From
FRANK T. CHAVEZ
District Supervisor

Case 8578

APPLICATION FOR CLASSIFICATION AS HARDSHIP GAS WELL

Re: San Juan 29-5 Unit #88

PRODUCTION HISTORY

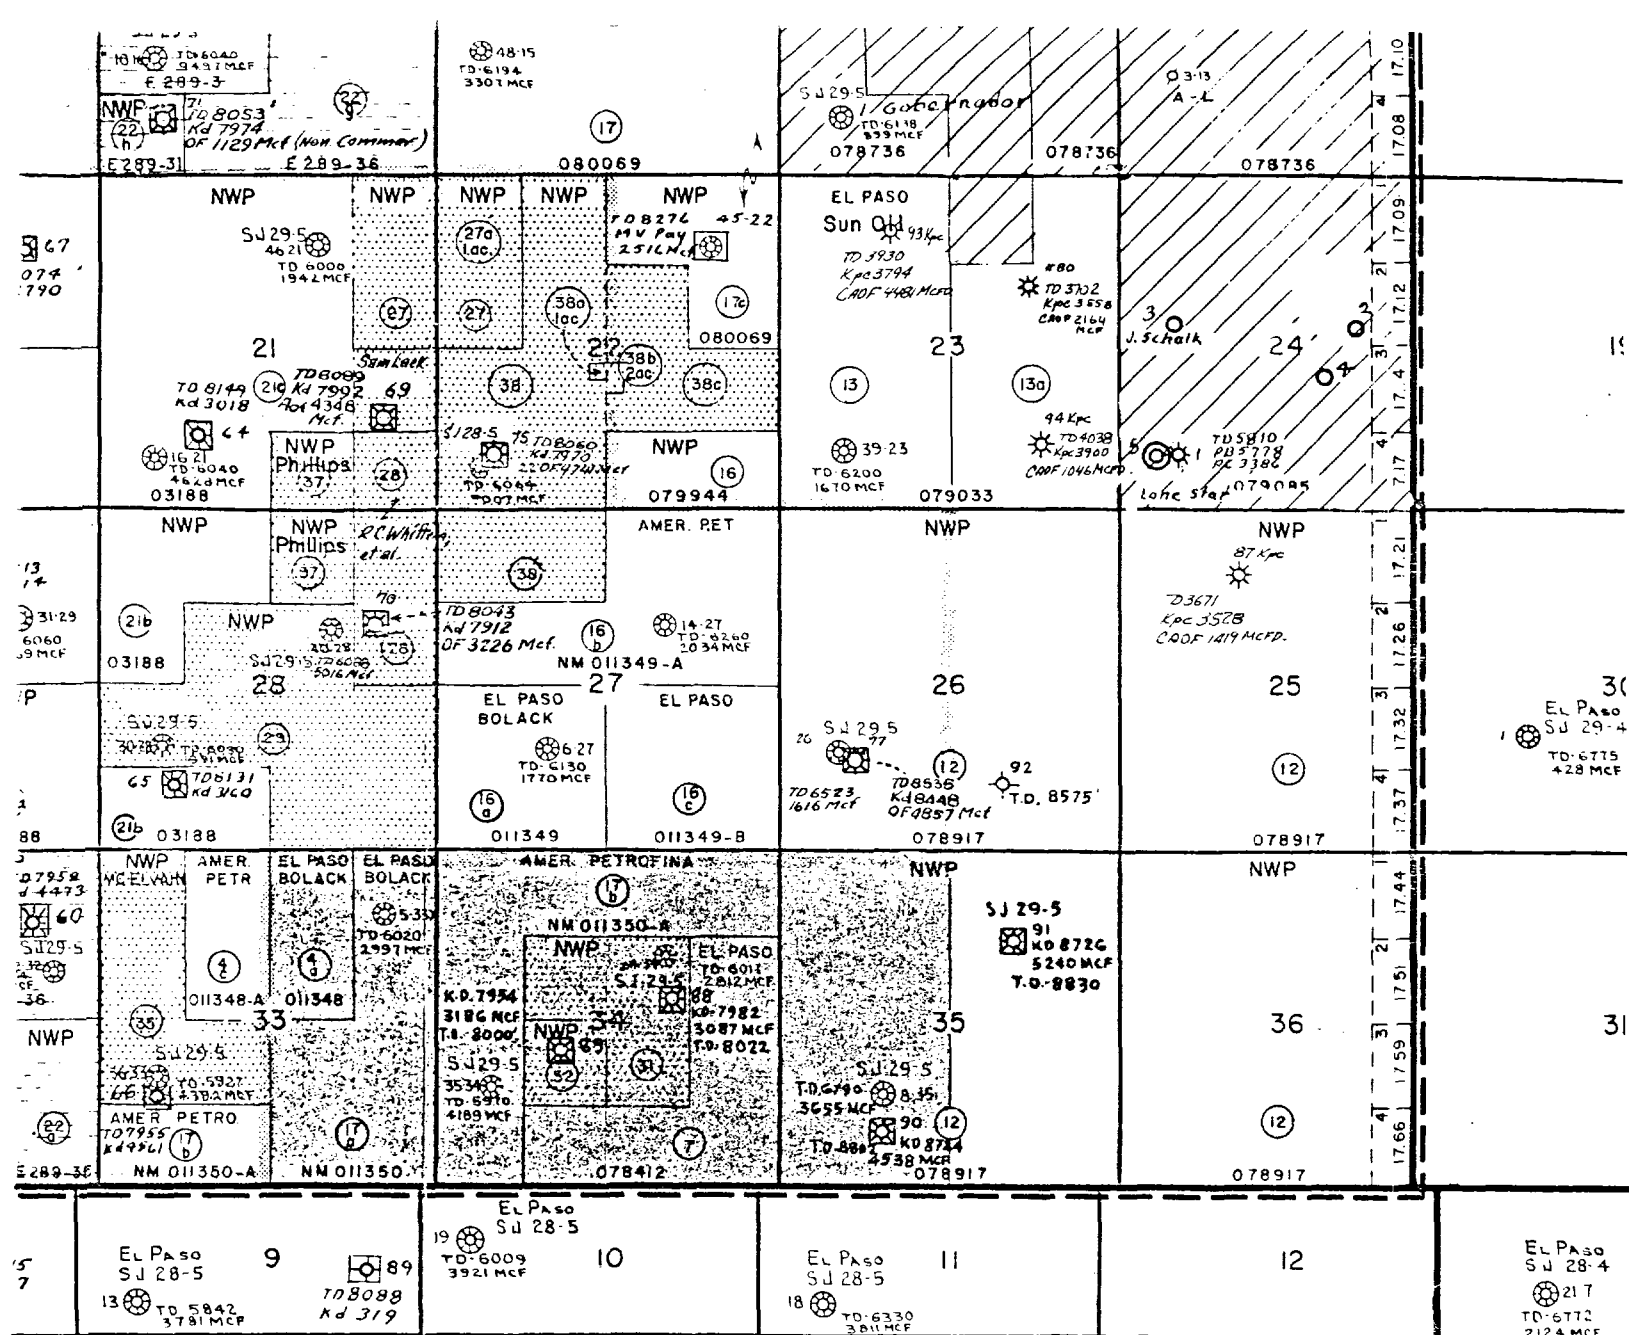
② *Fast decline in S.I. pressure
may indicate casing failure.*
